# **FINAL DRAINAGE REPORT – ADDENDUM NO. 1**

## **ARACO ENTERPRISES LLC - BUILDING ADDITION 7470 SOUTHMOOR DRIVE, FOUNTAIN, CO**

**JPS Project No. 111705  
PPR-1950**

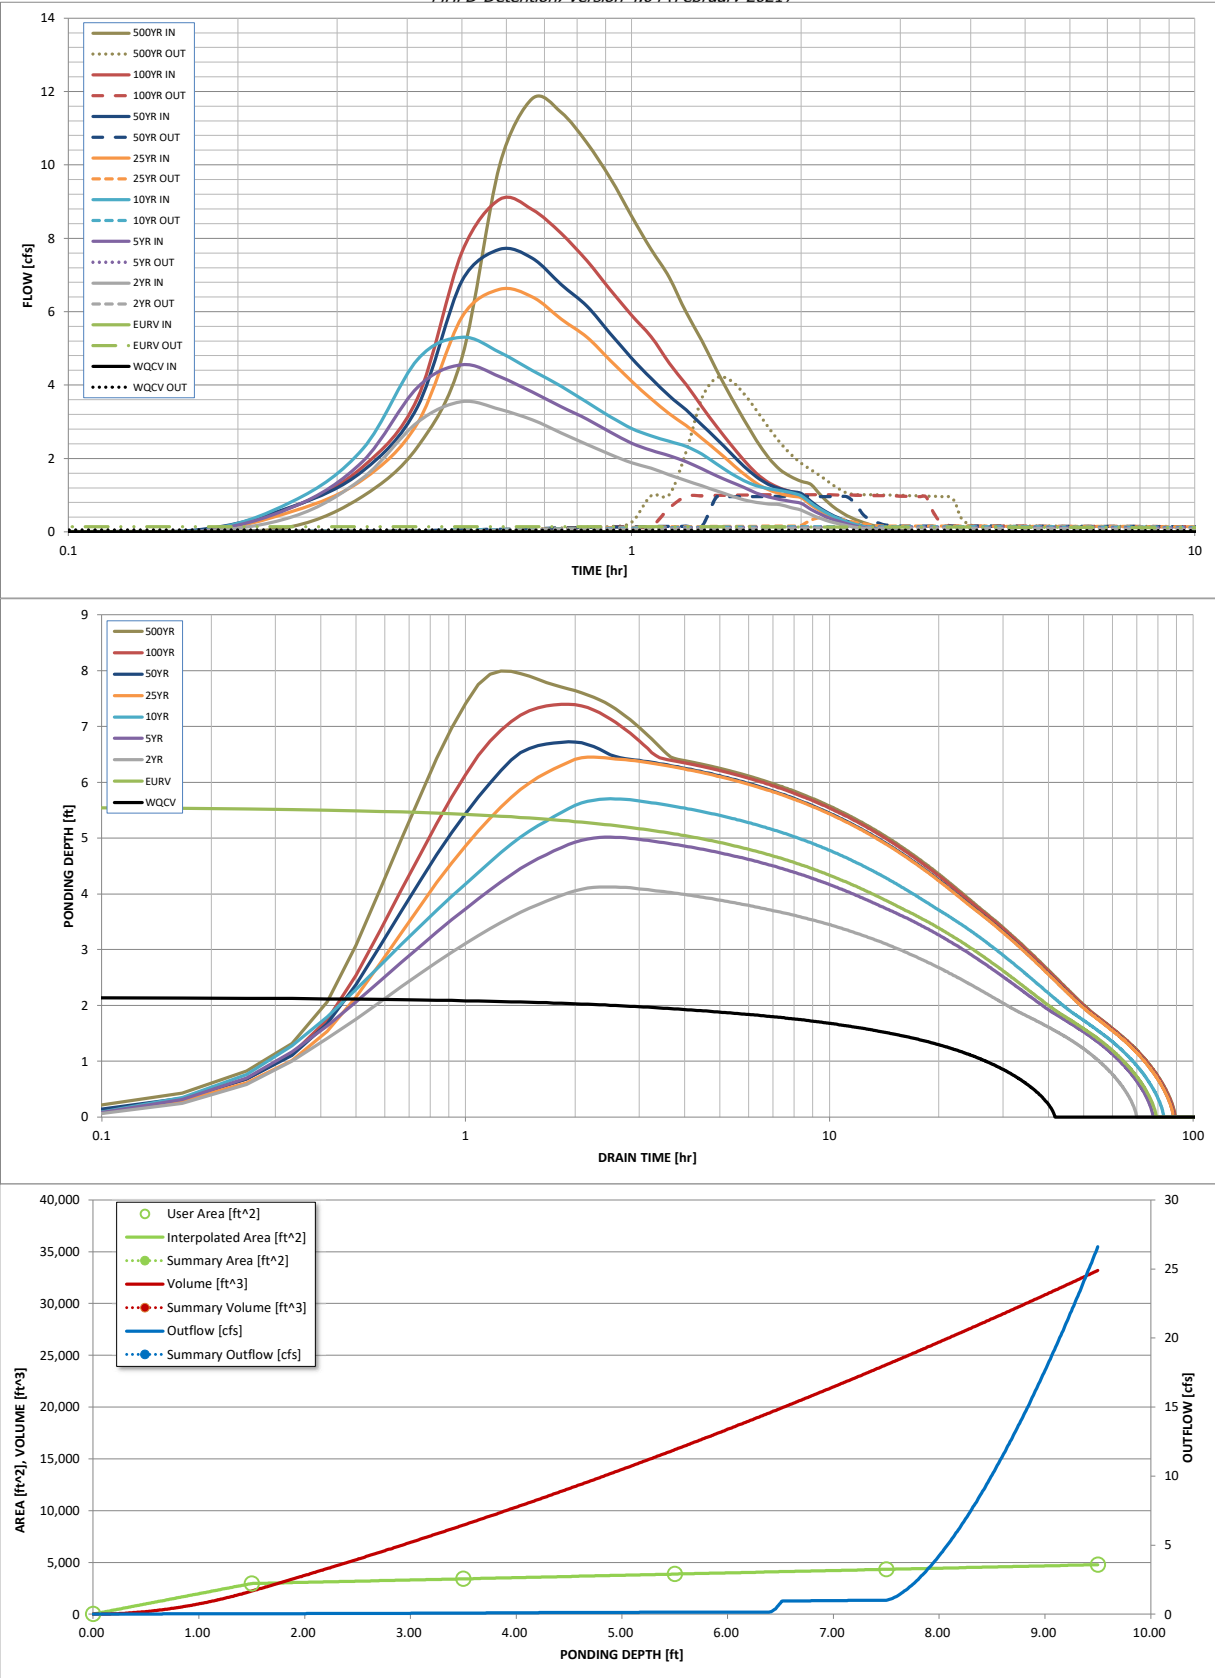
Add similar note from approved drainage report
